Soothing Dental PLLC Office  
SP 23-01 980 W. Ann Arbor Rd  
Site Plan Review  
PC Mtg 1/11/23

**Site Plan Review  
For  
Plymouth, Michigan**

**Subject:** 980 West Ann Arbor Trail – Site Plan Approval Review for Soothing Dental PLLC

**SITE PLAN PHASE 1**

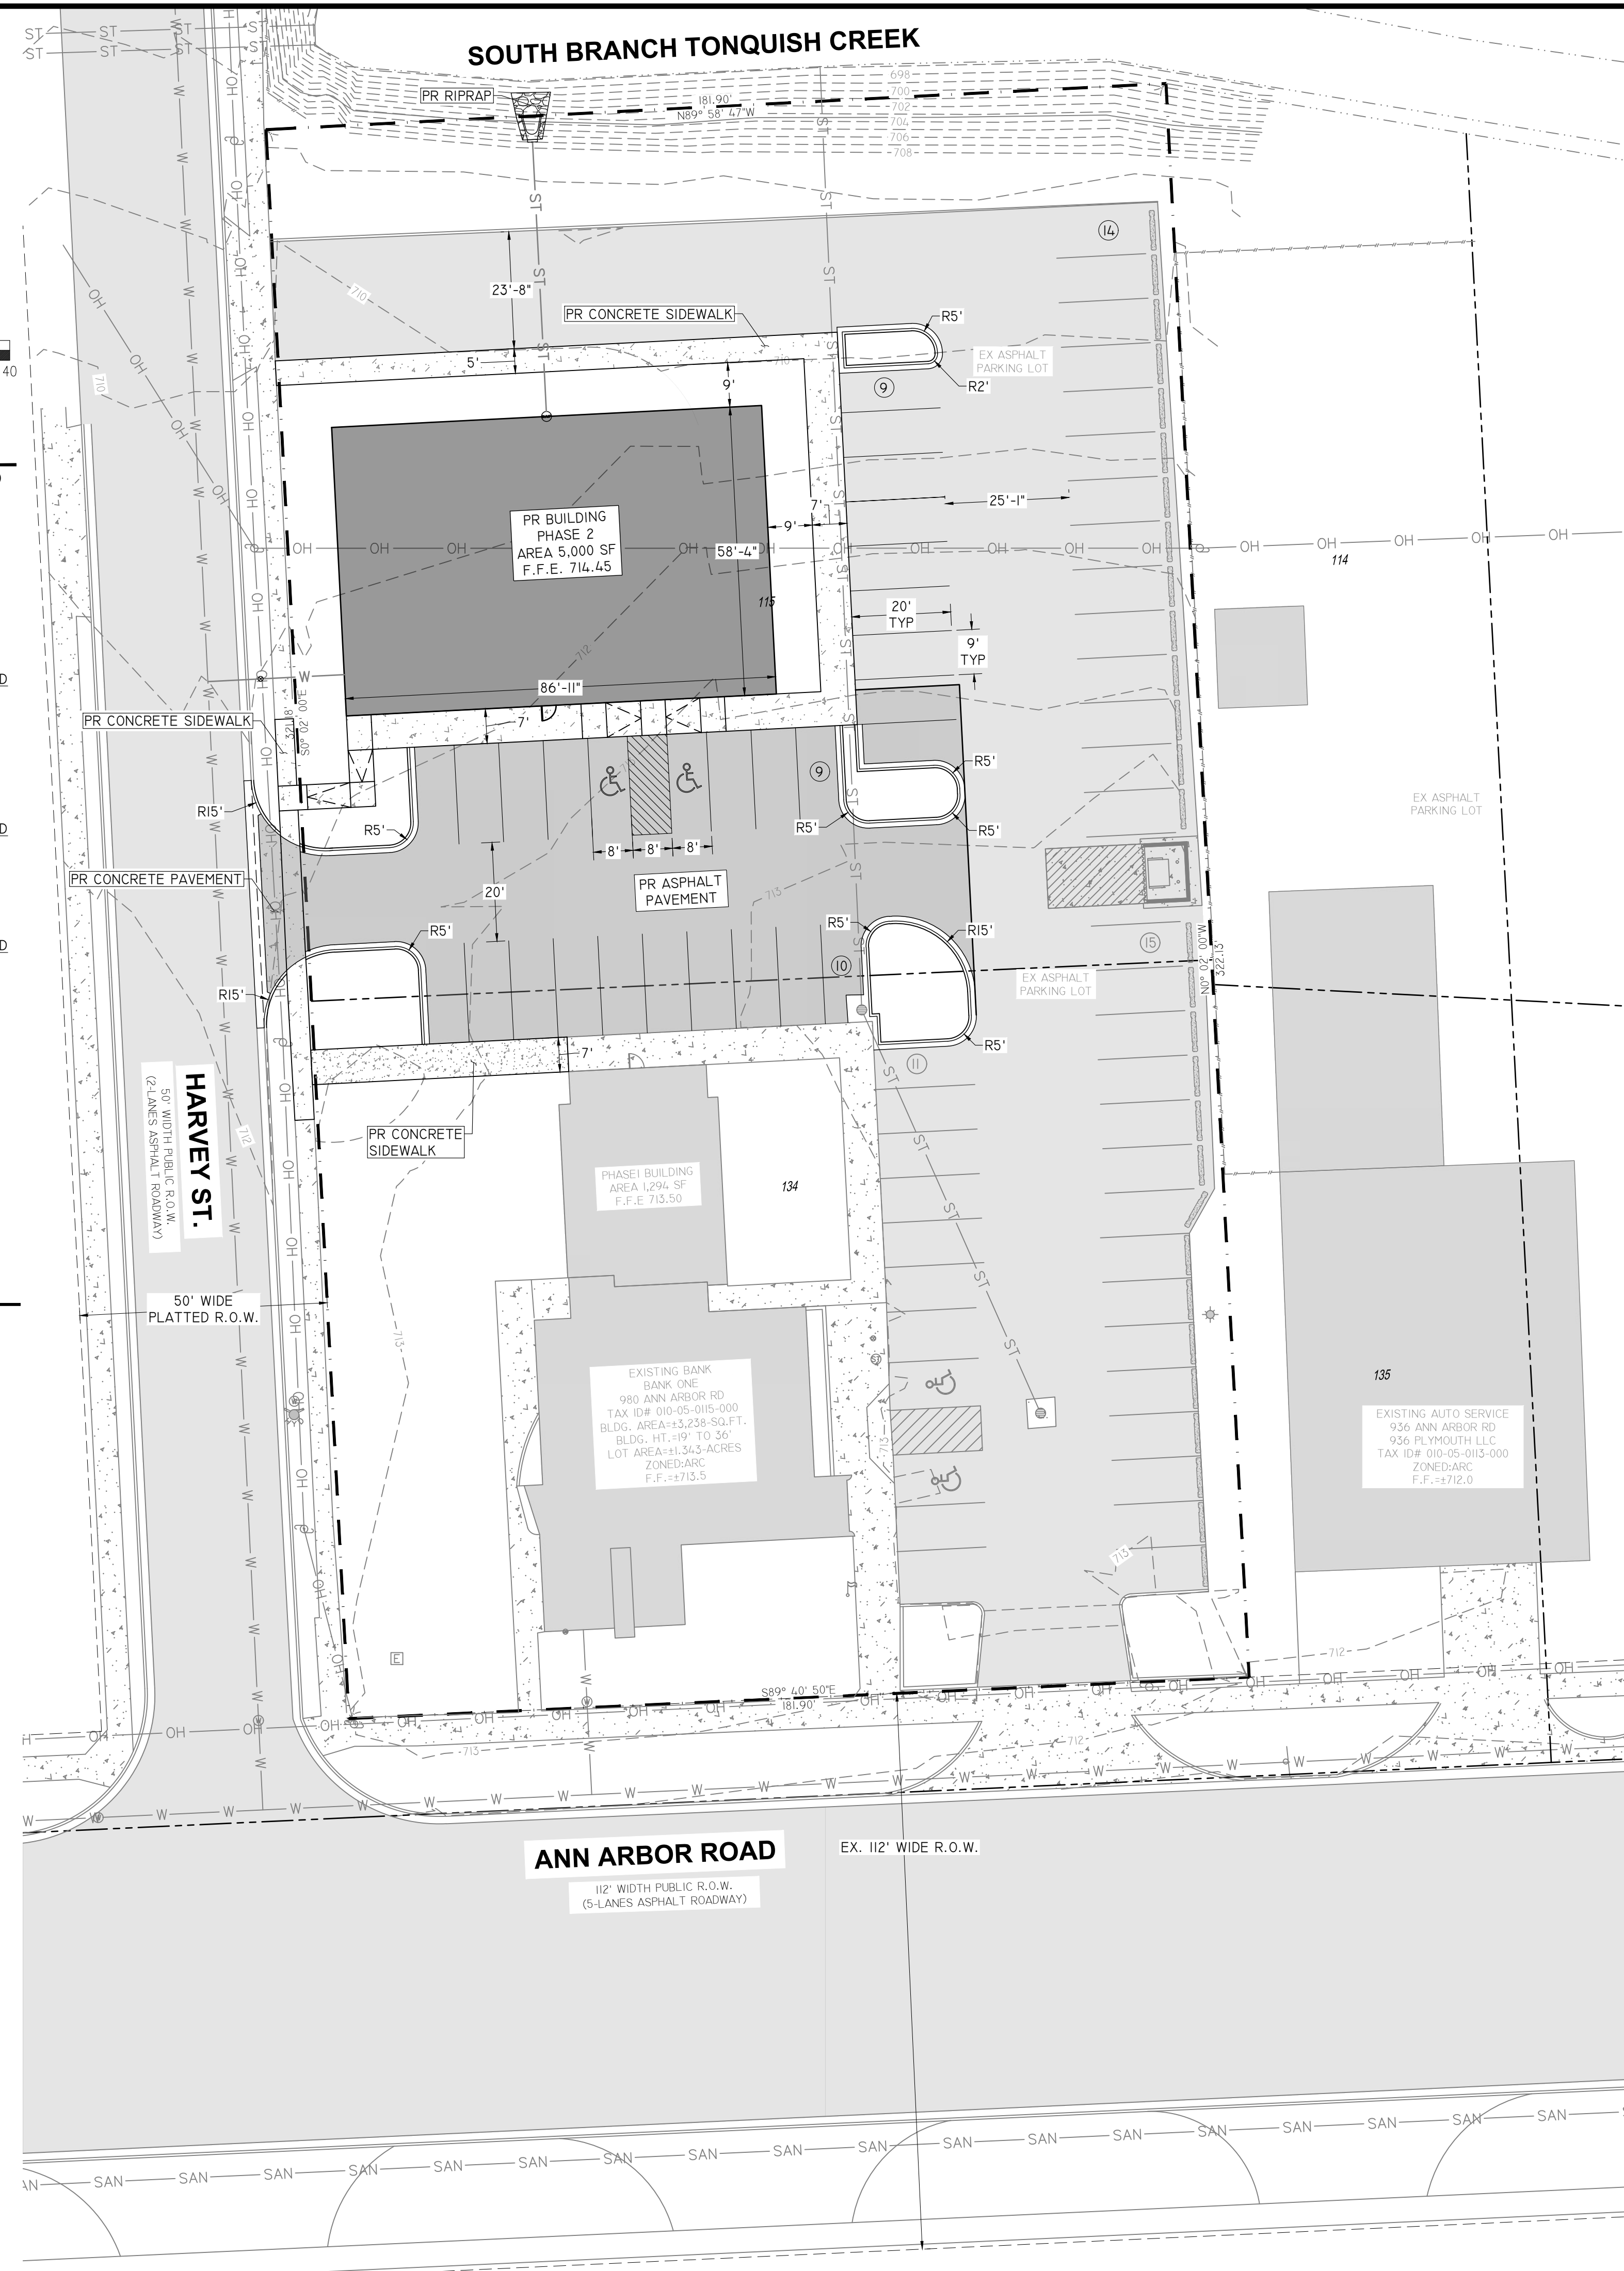
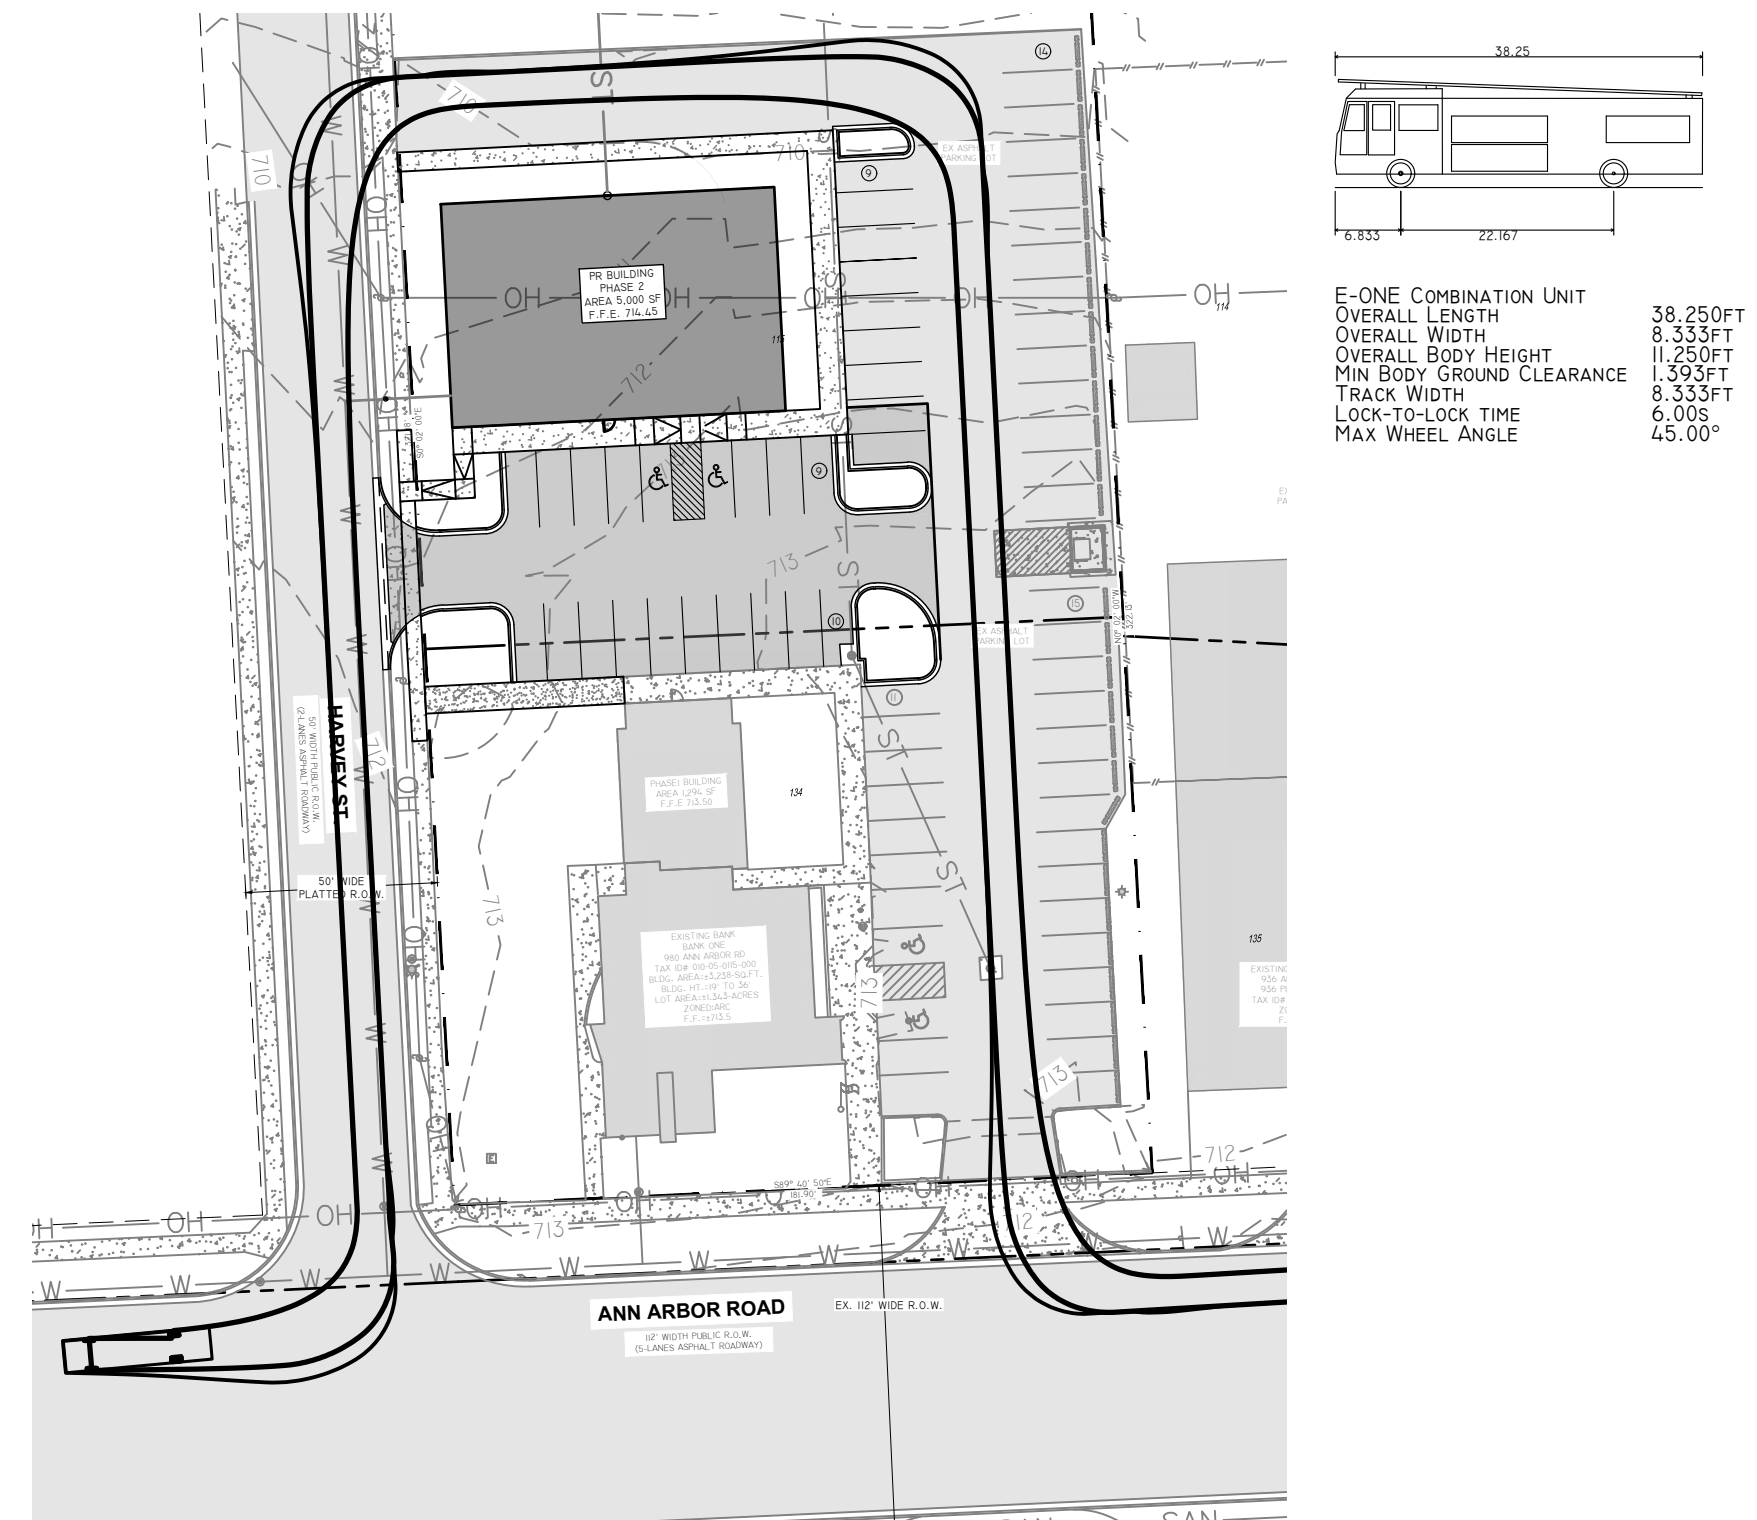
<sup>1</sup>Existing Building: Site Data Table (Sheet C3.0) and label on plans are inconsistent. Site Data Table shows existing building is 3,328 s.f.; label on plans shows existing building is 3,238 s.f.

<sup>2</sup>Proposed Building Addition (Phase I). Site Data Table (Sheet C3.0) and label on plans are inconsistent. Site Data Table shows proposed addition is 1,343 s.f.; label on plans shows proposed addition is 1,294 s.f.

<sup>5</sup>Side Setback. Site Data Table (Sheets C3.0 and Sheet C3.1) and scaled dimensions on plans are inconsistent. Site Data table shows proposed addition located at 78-feet from east property line; but plans scale at 101-feet. Site Data table shows proposed new building located at 75.916-feet from east property line; but plans scale at 85-feet.

The plans should illustrate how a delivery truck will traverse the site, where it will park, and what type of truck will be used for regular deliveries, if any. Sheet C3.0 shows how a trash hauler will access the dumpster and traverse the site.

Sec. 78-163 requires that parking lots be graded with proper drainage facilities provided to dispose of all surface water, per approval of the City Engineer. Sheet C3.0 shows that existing catch basins will be used to capture stormwater runoff from the new building addition (Phase I). For Phase II, Sheet C3.1 shows a storm line discharging stormwater directly to Tonquish Creek. We assume some type of pre-treatment will be required per the Wayne County Stormwater Standards. We defer evaluation of the proposed utilities to the City Engineer.

A dumpster screen that completely screens this area from the view of the street is required. Details of the proposed dumpster screen are shown on Sheet C3.0. The outside façade of the screen is 5.67-feet of brick to match the building, topped with coping, and then a 2-foot tall decorative fiber-cement fiberboard and decorative metalwork.

**Items to be Addressed:** 1) Correct/clarify plans so that dimensions in Site Data Table and labels on plans are consistent. 2) Shift proposed building (Phase II) to be located at least 75 feet from the rear property line. 3) Provide architectural building information for new building (Phase II) to enable confirmation of all bulk requirements.

SHEET TITLE: **SITE PLAN PHASE 2**

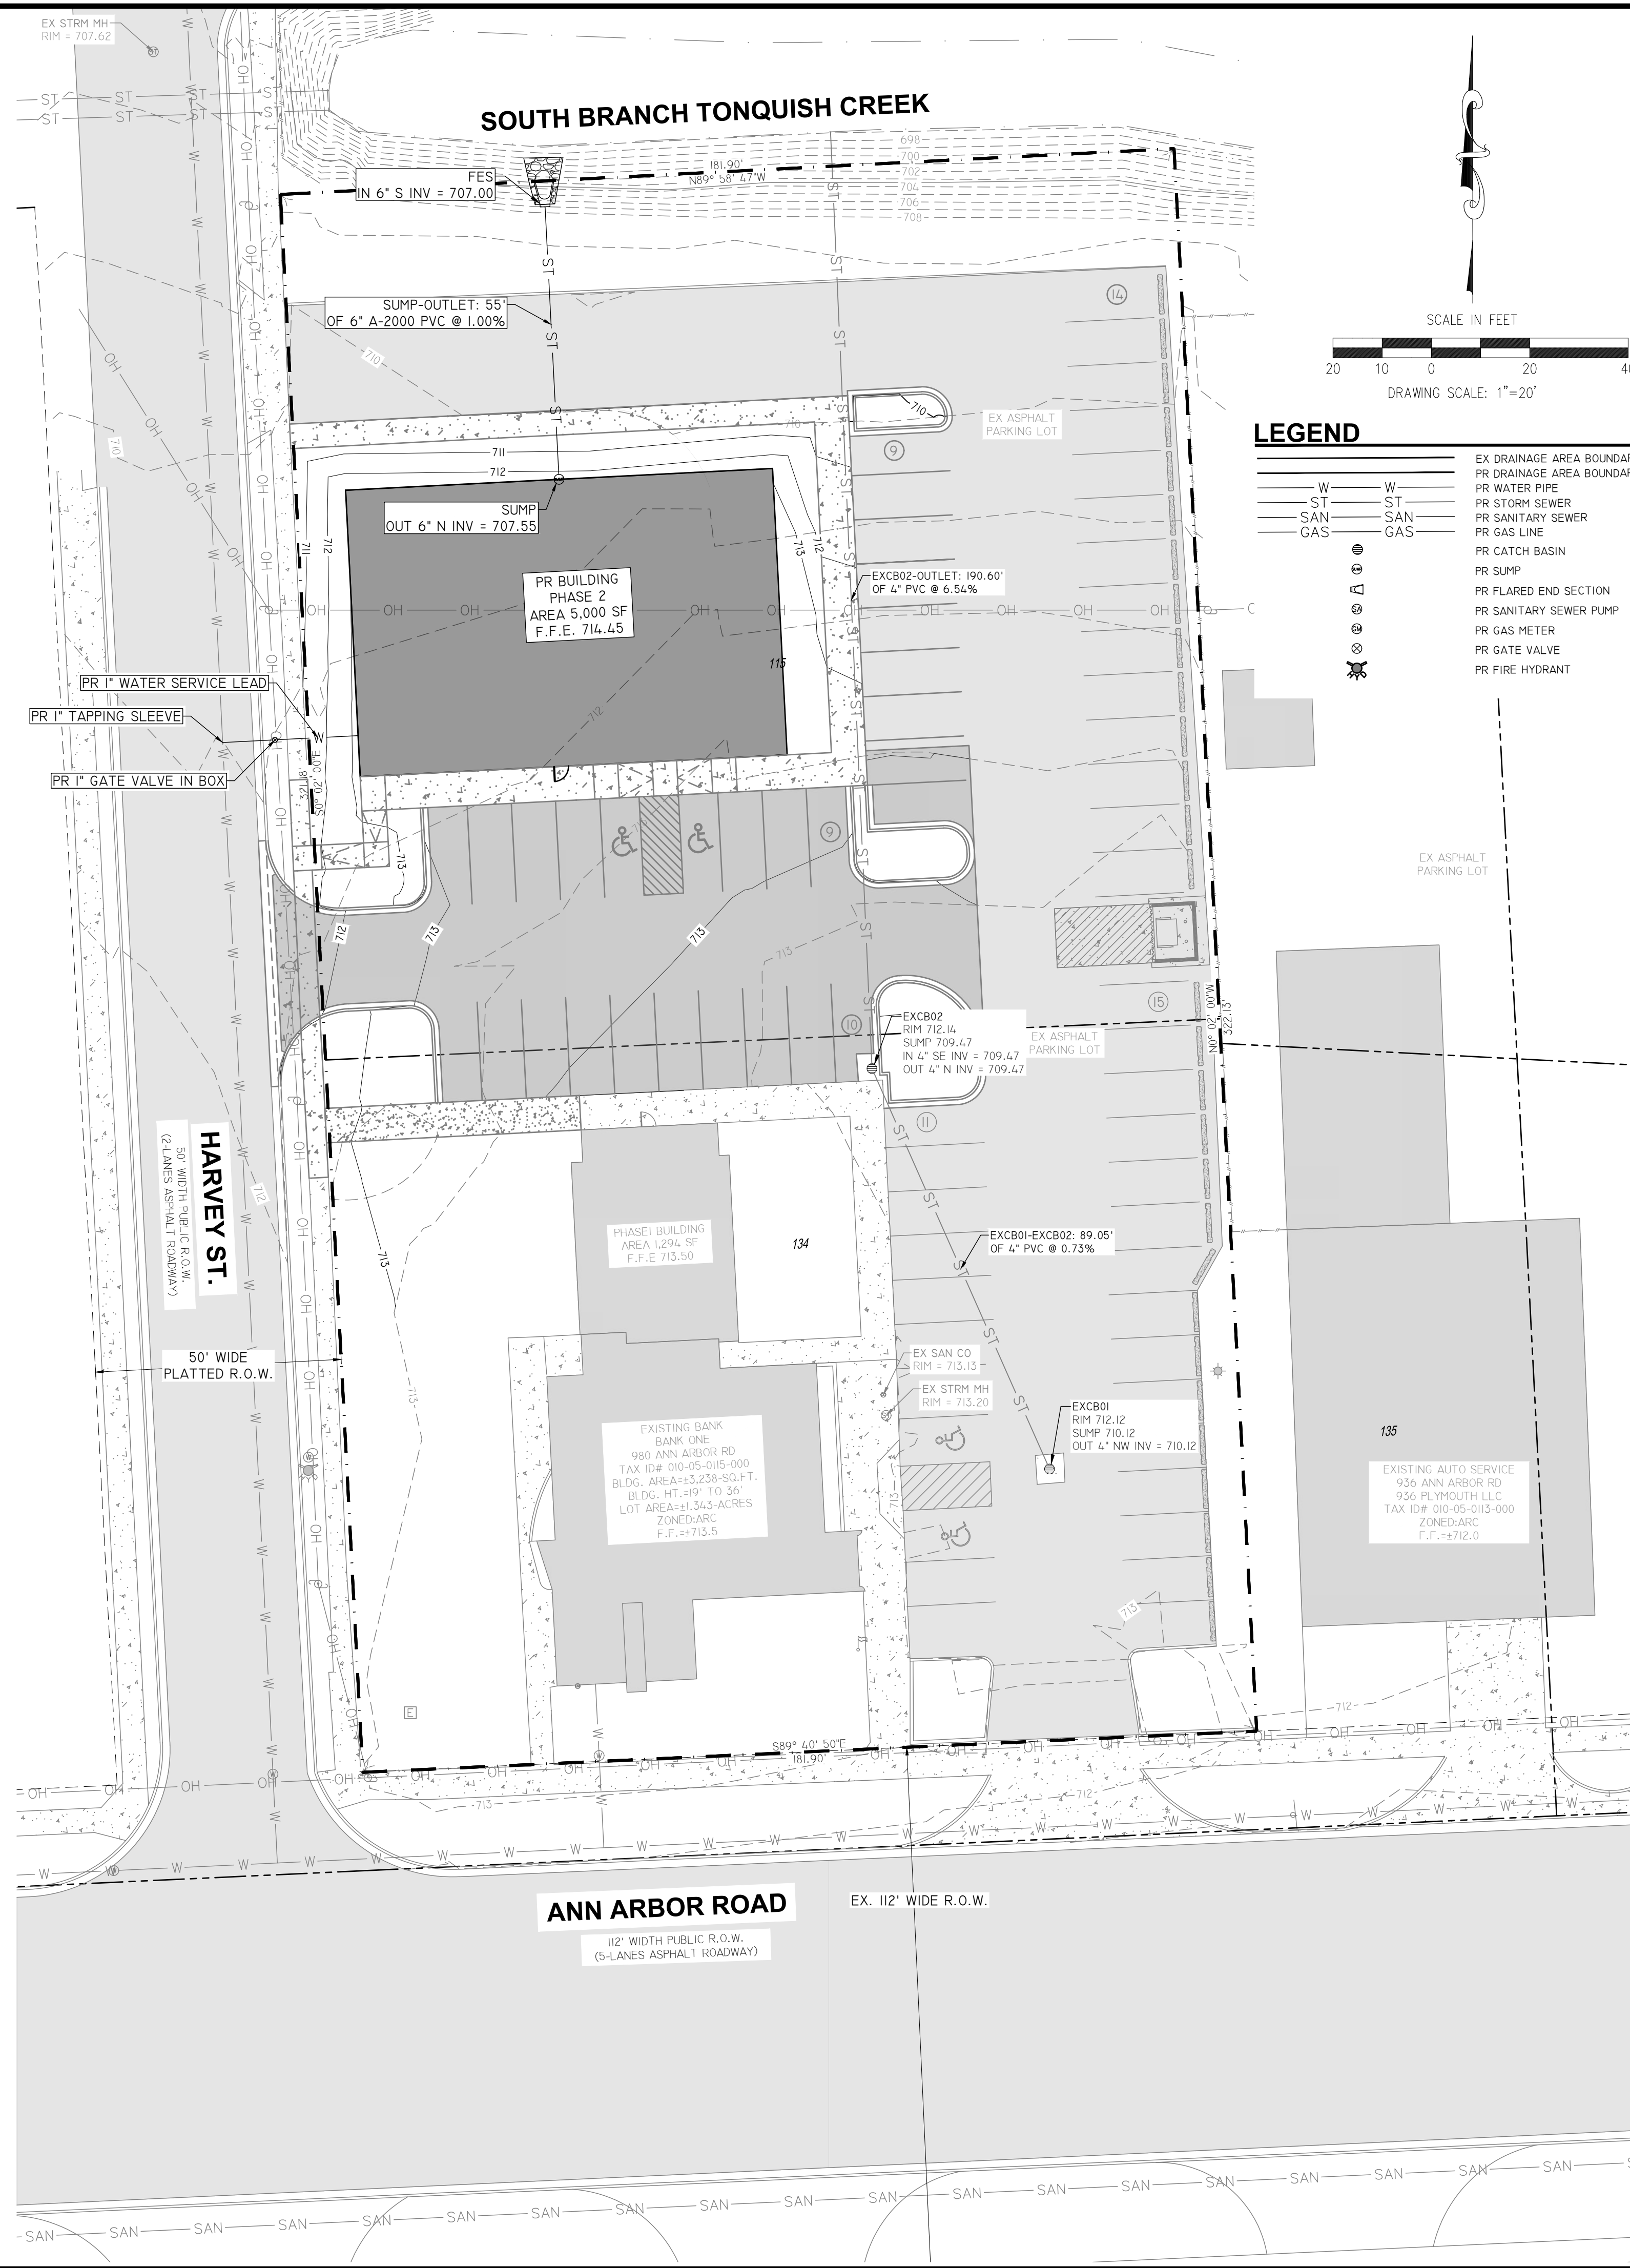
<sup>3</sup>Proposed New Building (Phase II). Site Data Table (Sheet C3.1) and label on plans are inconsistent. Site Data Table shows proposed new building is 6,450 s.f.; label on plans shows proposed addition is 5,000 s.f.
